- APPENDUM #1 ITEMS (11-09-21)**
- A1-1 Existing grass area shall be re-graded to provide finish elevation below adjacent sidewalk and prevent erosion onto sidewalk
 - A1-2 Existing deck steel handrail and guardrail shall be prepped and repainted
 - A1-3 Existing bulkhead deck shall be removed and replaced ~ See Detail A-SP-PM2
 - A1-4 Existing water feature shall be protected
 - A1-5 All shade types shall be separate alternate bid items
 - A1-6 Existing reinstalled ADA lift, deck anchor, and tile deck marker shall be omitted ~ New ADA lift shall be provided ~ Aqua Creek Ambassador Reverse, with dual flip-up arms, adjustable flip-up footrest, lap belt, headrest, safety cover, additional battery, battery charger, jumbo handset remote, chest strap, and 5" seat cushion

WICHITA, KANSAS
Pool Improvements
COLLEGE HILL PARK

Date: 09-27-21 Job #: 18-512
 Drawn: SRS Checked: JAB
 Issue: CONSTRUCTION DOCUMENTS

A POOL PLAN
Scale: 3/32"=1'-0"

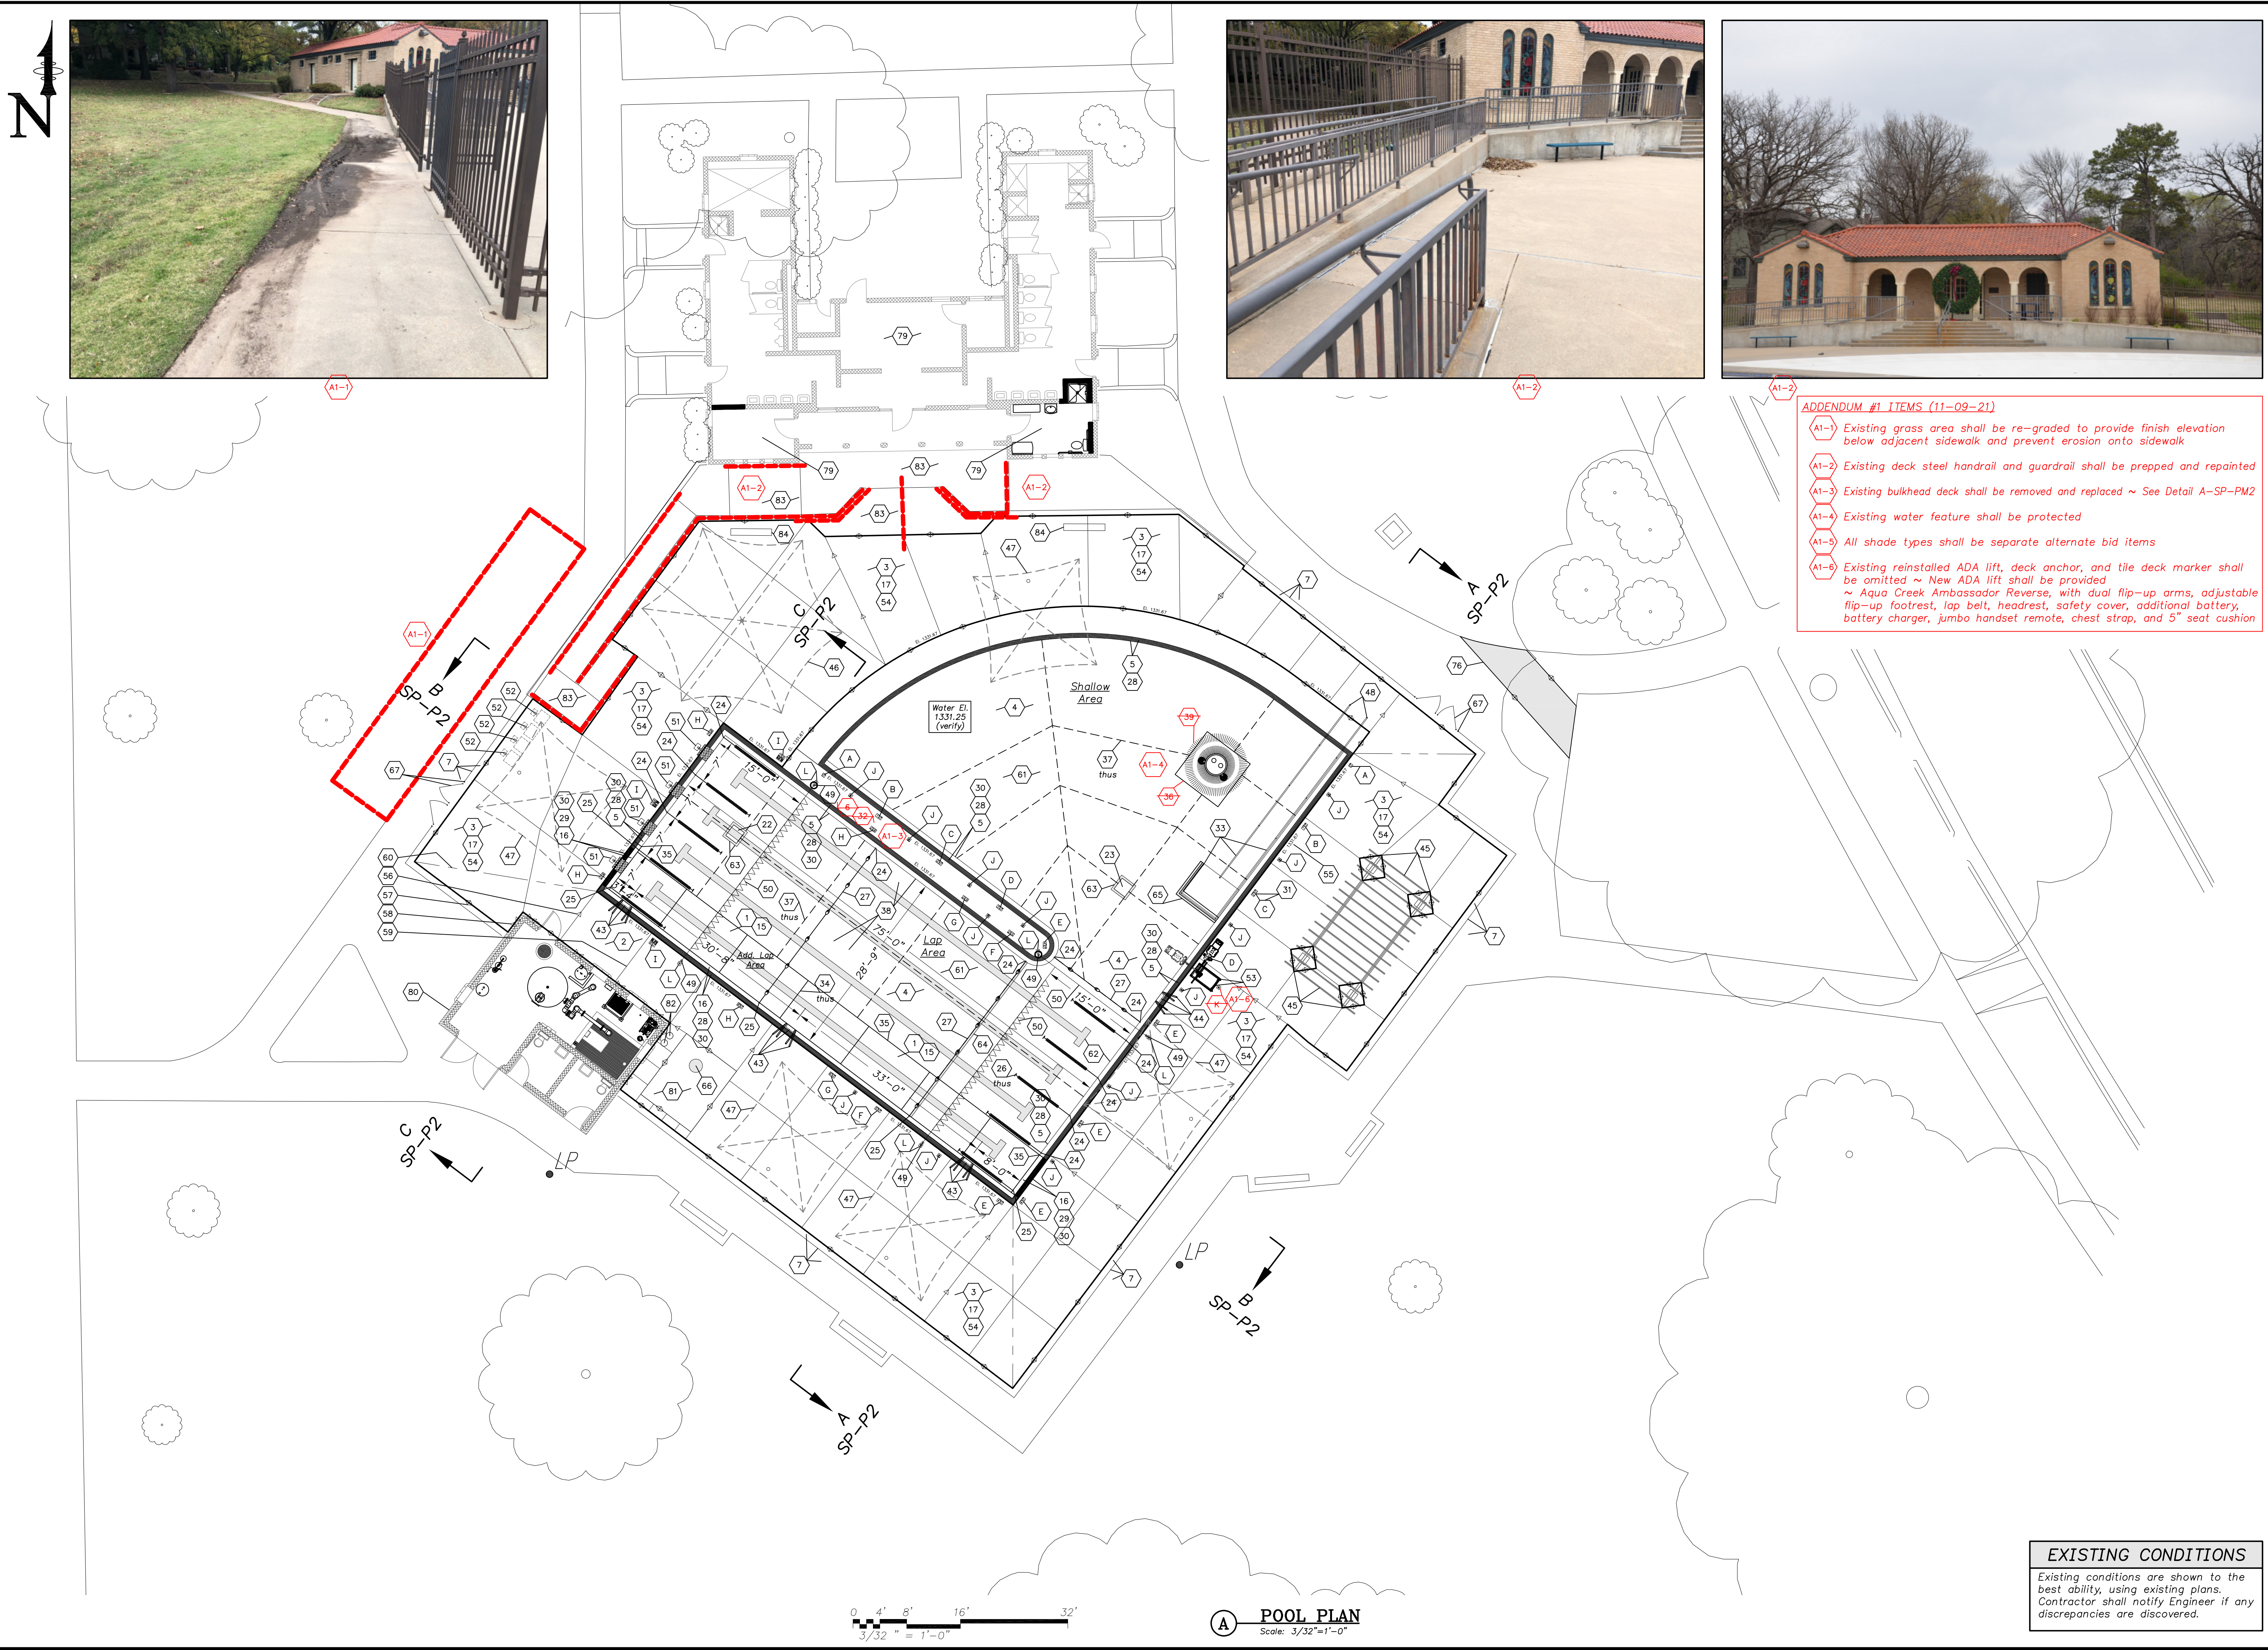
- ~~20 Feature piping - (A1-4)~~
- 21 Connection at existing piping to new piping
- 22 Deep area main drain VGB grate ~ Approx. 24" x 24" ~ Contractor shall verify ~ Raised finish with adjacent pool floor ~ Anchor per mfr. with S.S. hardware

- 35 Pool floor/wall to existing pool floor/wall ~ See Detail D-SP-PM3
- ~~A1-3 36 Pool floor repair ~ See Detail E-SP-PM3~~
- 37 Existing pool construction joints (floor and wall) shall be filled with crystalline repair material ~ Grind existing joints to be clean and minimum 1" wide x 1 1/2" deep

- ~~A1-4 39 "Vortex Frog No. 5" ~ See Detail F-SP-PM4~~
- 40 Pool wall construction joint equally spaced ~ See Detail G-SP-PM4
- 41 Gutter outlet ~ See Detail I-SP-PM4

- 45 Existing gazebo and footings
- ~~A1-5 46 Sunshade types
Base Bid Alternate bid
~ Mfr. Solar Shade
~ Approx. 30' diameter, single post, standard, hexagon
Alternate bid 1
~ Mfr. Solar Shade
~ Approx. 30' diameter, single post, custom rolled
Alternate bid 2
~ Mfr. Tensile Shade Products
~ Approx. 30' diameter, single post, Trillium~~

- ~~A1-5 47 Sunshade types
Base Bid Alternate bid
~ Mfr. Solar Shade
~ Approx. 16' x 16', single post, cantilever, standard, square
Alternate bid 1
~ Mfr. Solar Shade
~ Approx. 16' diameter, single post, hexagon, custom alternating high/low arms
Alternate bid 2
~ Mfr. Tensile Shade Products
~ Approx. 17' x 19', single post, cantilever, Visor~~

- ~~A1-6 53 Existing portable ADA lift provided by Owner (N.I.C.)
~ Contractor shall provide "Secure It Kit" deck anchor~~
- 54 Pool deck ~ See Detail N-SP-PM4 ~ Deck and drain finish surface elevations
~ Deck slopes shall be 1% min. / 2% max.
~ Water shall not be allowed to pond in any location
~ New deck elevations shall match flush with existing deck/sidewalk elevations

- ADDENDUM #1 ITEMS (11-09-21)**
- (A1-1) Existing grass area shall be re-graded to provide finish elevation below adjacent sidewalk and prevent erosion onto sidewalk
 - (A1-2) Existing deck steel handrail and guardrail shall be prepped and repainted
 - (A1-3) Existing bulkhead deck shall be removed and replaced ~ See Detail A-SP-PM2
 - (A1-4) Existing water feature shall be protected
 - (A1-5) All shade types shall be separate alternate bid items
 - (A1-6) Existing reinstalled ADA lift, deck anchor, and tile deck marker shall be omitted ~ New ADA lift shall be provided ~ Aqua Creek Ambassador Reverse, with dual flip-up arms, adjustable flip-up footrest, lap belt, headrest, safety cover, additional battery, battery charger, jumbo handset remote, chest strap, and 5" seat cushion

POOL MECHANICAL PLAN
 Scale: 3/32"=1'-0"

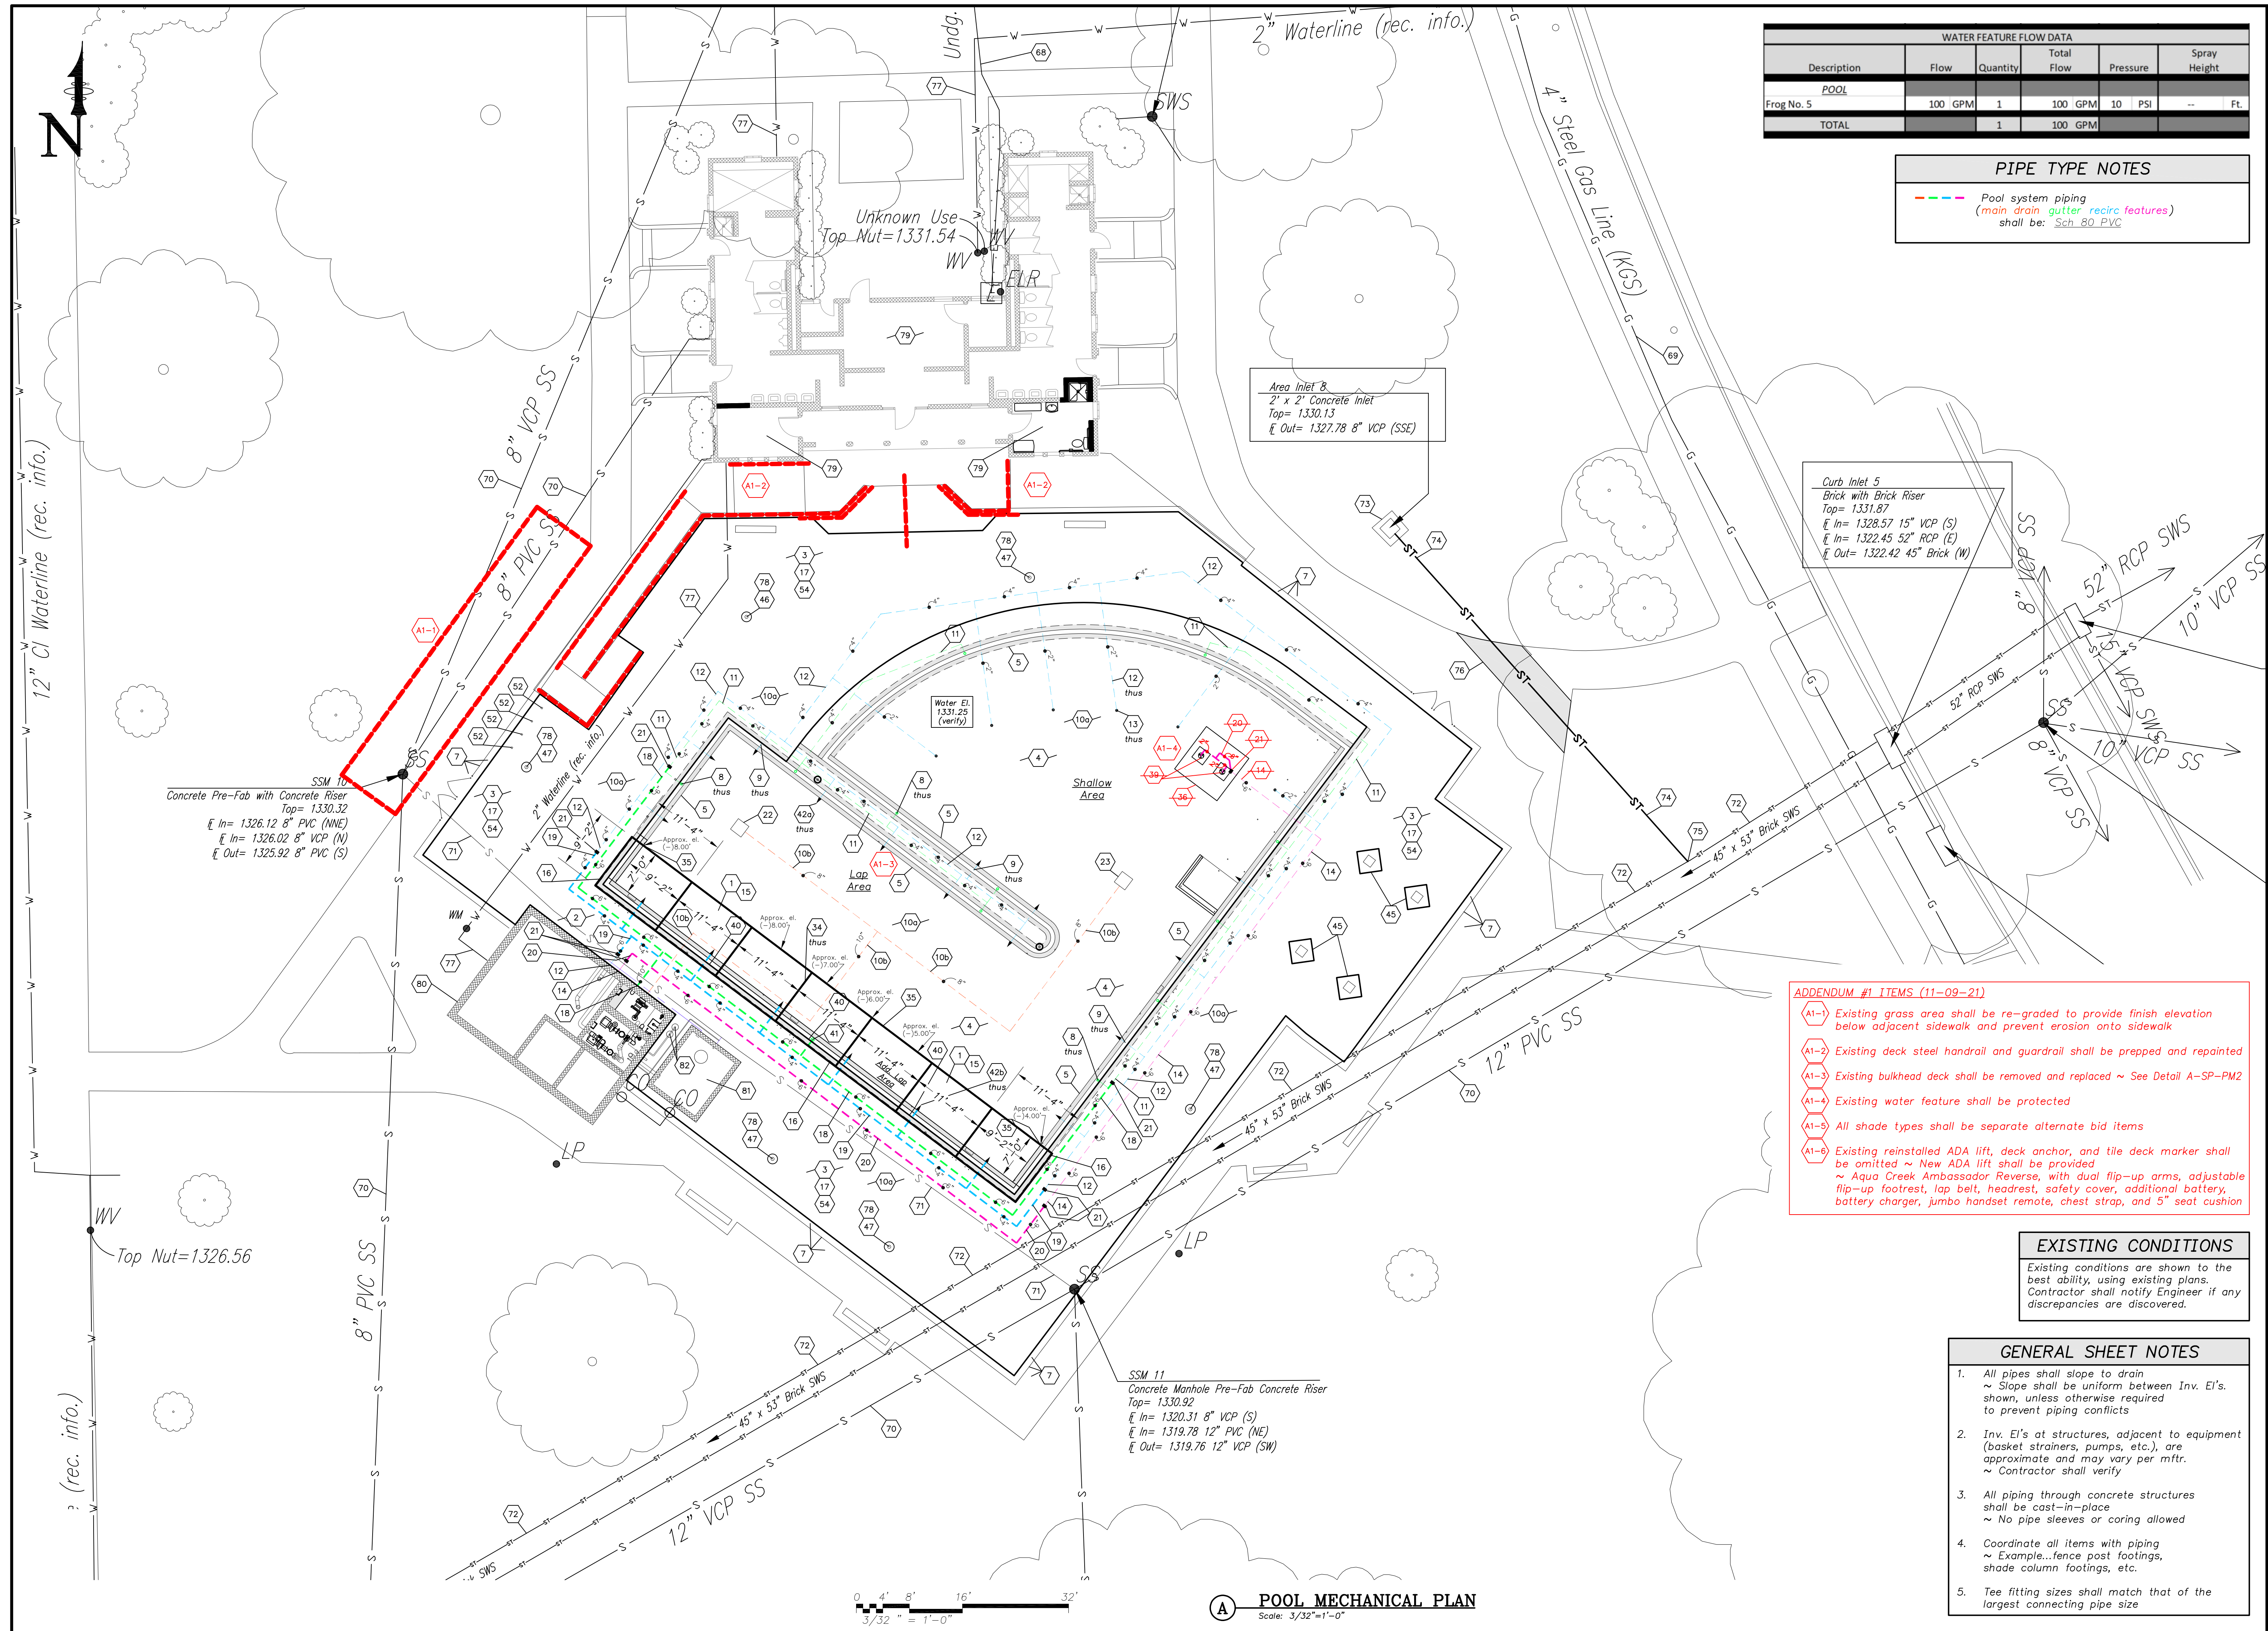
ADDENDUM #1 ITEMS (11-09-21)

- (A1-1) Existing grass area shall be re-graded to provide finish elevation below adjacent sidewalk and prevent erosion onto sidewalk
- (A1-2) Existing deck steel handrail and guardrail shall be prepped and repainted
- (A1-3) Existing bulkhead deck shall be removed and replaced ~ See Detail A-SP-PM2
- (A1-4) Existing water feature shall be protected
- (A1-5) All shade types shall be separate alternate bid items
- (A1-6) Existing reinstalled ADA lift, deck anchor, and tile deck marker shall be omitted ~ New ADA lift shall be provided ~ Aqua Creek Ambassador Reverse, with dual flip-up arms, adjustable flip-up footrest, lap belt, headrest, safety cover, additional battery, battery charger, jumbo handset remote, chest strap, and 5" seat cushion
